**STAFF REPORT
(One-Step Final Plat)**

CASE NUMBER: SUB 2001-126 – REFLECTION RIDGE WEST 2ND ADDITION

LOCATION: East side of Tyler Road, North of 21st St. North

SUB2001-126
Site Plan

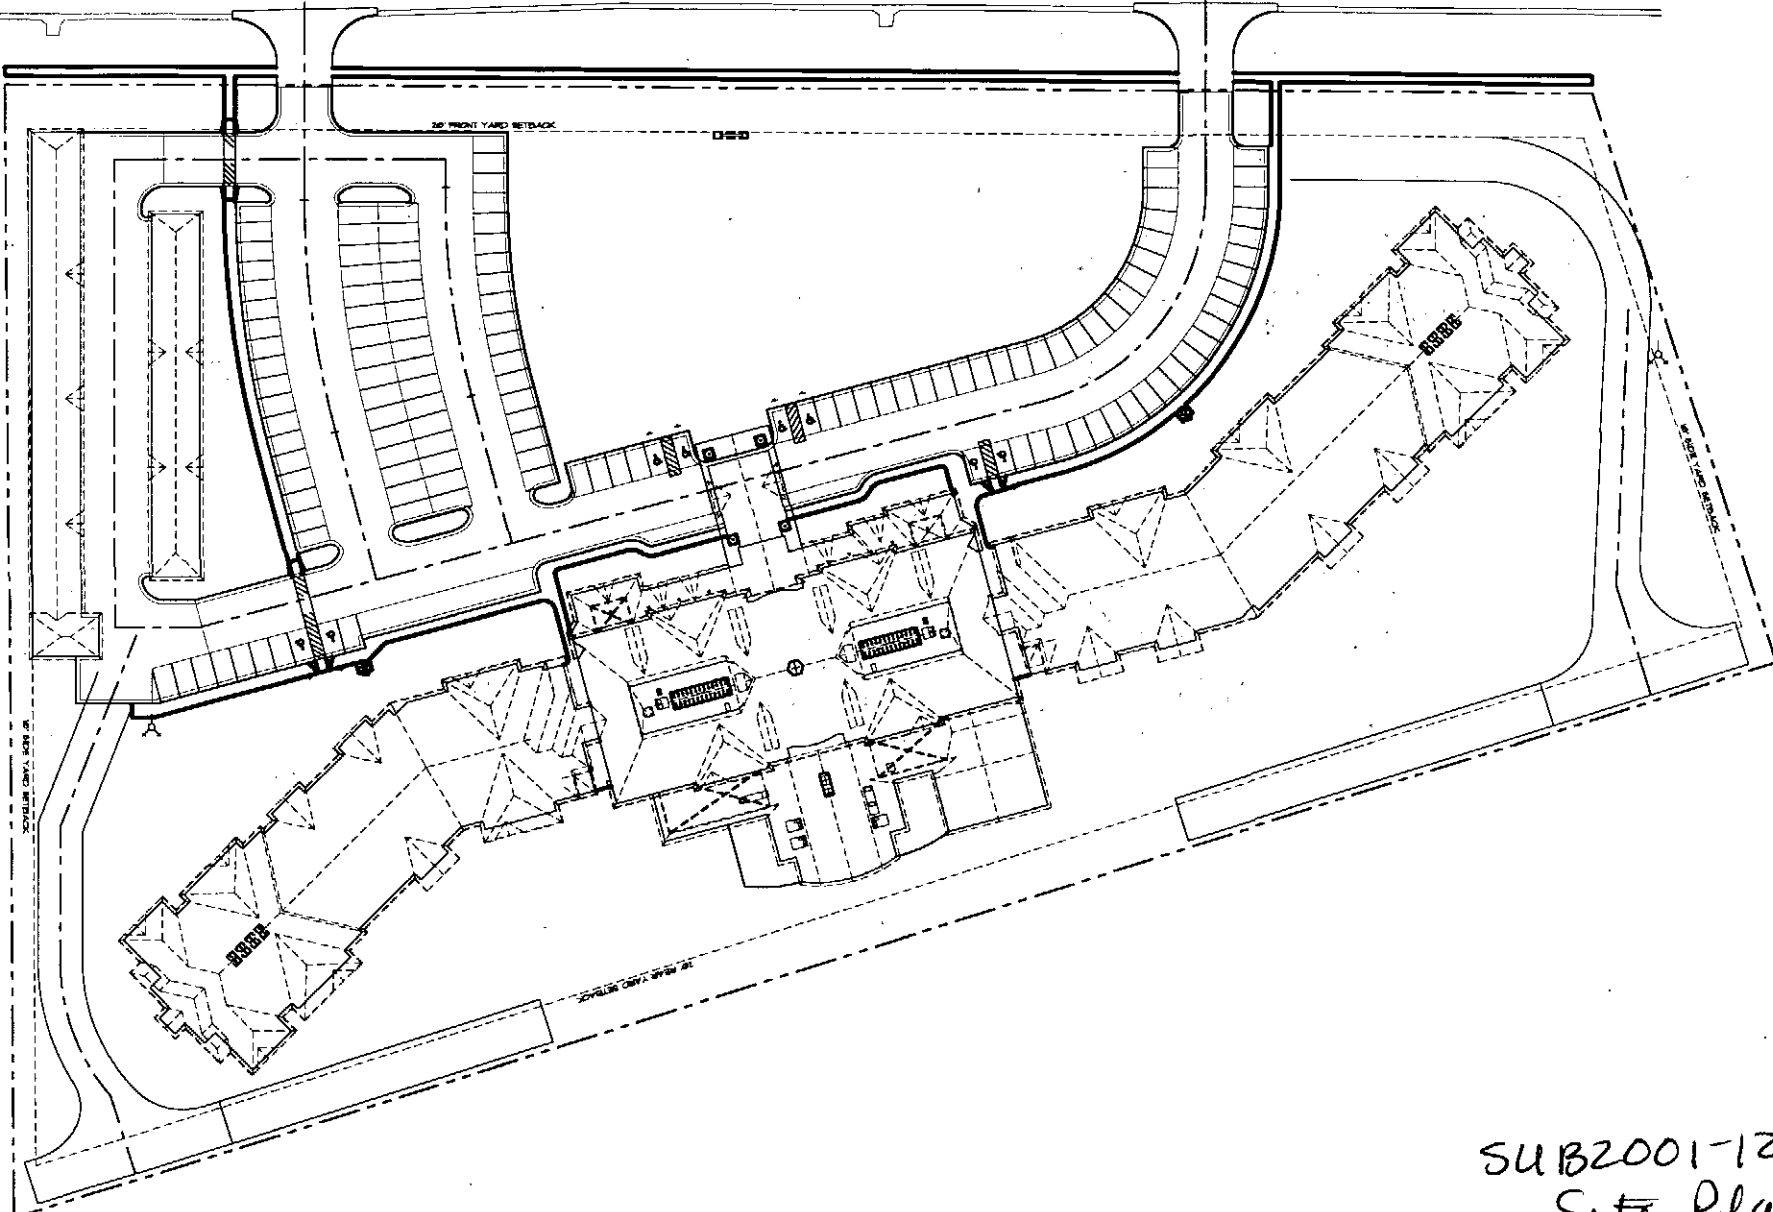
- C. **City Engineering** needs to comment on the status of the applicant's drainage plan.
- D. In accordance with the CUP, the plat proposes two access openings along Tyler. The CUP also required a 300-ft minimum separation between the openings which should be denoted on the face of the plat. The final plat tracing shall reference the access controls in the plat's text. **Traffic Engineering has required the relocation of the south opening denoted on the site plan to the north to align with the north parking aisle. Complete access control needs to be dedicated along Tyler south of this opening.**

- F. The plat encompasses Parcels 1, 1A, 1B and 1C of the associated CUP. A CUP adjustment may need to be approved to have the parcel boundaries coincide with the lot.

- G. The plat's text shall include language that a drainage plan has been developed for the plat and that all drainage easements, rights-of-way, or reserves shall remain at established grades or as modified with the approval of the applicable City or County Engineer, and unobstructed to allow for the conveyance of stormwater.
